ARCHITECTURAL REVIEW & APPROVAL

GOLD PARK HOMES

PROJECT/LOCATION
MCLAUGHLIN AND MAYFIELD
BRAMPTON, ON

SITE PLAN

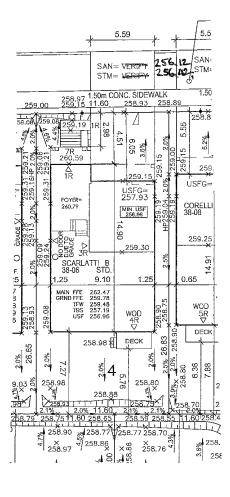
No final utility location information at this time. Urbantech will not be responsible for future changes to design. Builder should notify purchaser's that street hardware and above ground utility furniture may be added or removed from their finategae.

Builder to lower underside of footings where adjacent to RLCB leads.
 Exact depth to be determined on site during footing excavation.

Builder to stake out driveway curb depressions at time of curb installation.

Builder to verify location of all hydrants, street lights, transformers and all other services. If min. dimensions are not maintained as per City standards, builder is to relocate at his own expense.

Builder to confirm service connection elevations and review for absence of onflict prior to footing excavation.

6) Final fence design have not been provided at this time, Purchaser to be advised that actual fencing details may not be as shown on this plan.
